Schemes Planning and Delivery Team working in Partnership with Horsmonden Parish Council Highway Improvement Plan

Submission Date: 17/03/2022

HIP Front Cover

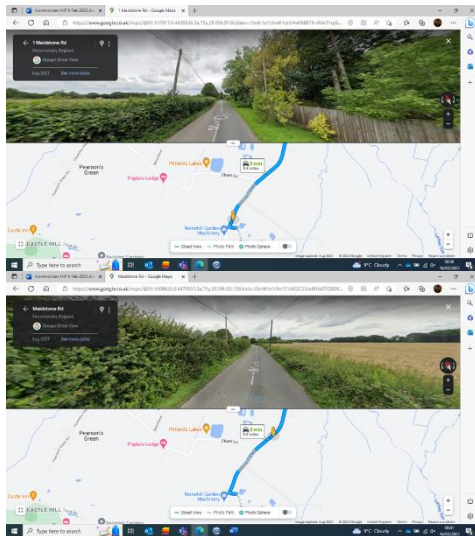
<p>locations to get a good indication of vehicle speeds, and ET will arrange.</p>  <p>Refresh of line markings: Unable to find any jobs/ enquiries re a request for the lining to be refreshed at the junction of Yew Tree Green Road and Maidstone Road. Parish Council to confirm if the markings below still need refreshing and ET will log and provide the Parish Council with a reference</p>
--	--	--	--	--

<p>number to track via the online fault reporting tool.</p>  <p>17.03.23 - Refresh of line markings is logged under ref. 644378. Job was completed 16.03.23 to carry out carriageway patching along with 5m of edge lining and a refresh of junction markings, triangle and centre lines.</p> <p>Update 04.04.23 - The Parish Council agreed the two proposed locations on Maidstone Road for the ATCs. ET to arrange and update the PC on dates that the survey will be on site.</p>

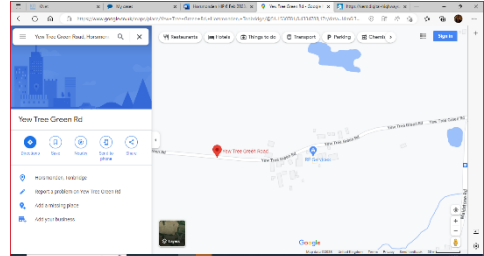
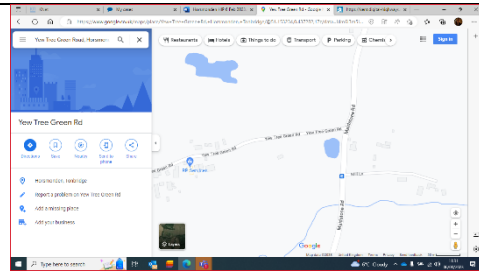
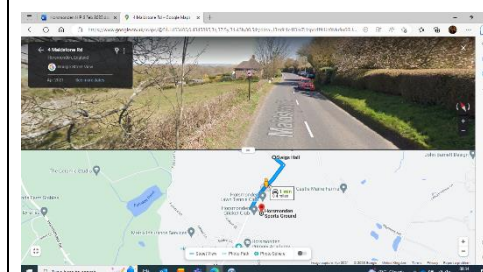
<p>on this road. However, we will require specific locations, as there are several bends on this road. We can then examine the specific proposals and establish viability.</p> <p>06.03.23 - Parish Council confirmed that they would like a sign on the bend before RP Services and ahead of the first bend, travelling away from Maidstone Road (screenshots below):</p> 
--	--	--	--	--

<p>ET to raise with Design & Delivery and enquire as to whether a SLOW marking could be added in conjunction with the warning signs as this may reduce the need for a speed limit reduction given average speeds (ranging from 30.17mph to 32.14mph) and lack of available verge space to install 30mph repeater signs.</p> <p>Update 16.03.23 - ET has raised this request with Design & Delivery under the original reference 12408900, and will feed back to the Parish Council once the review is complete.</p>
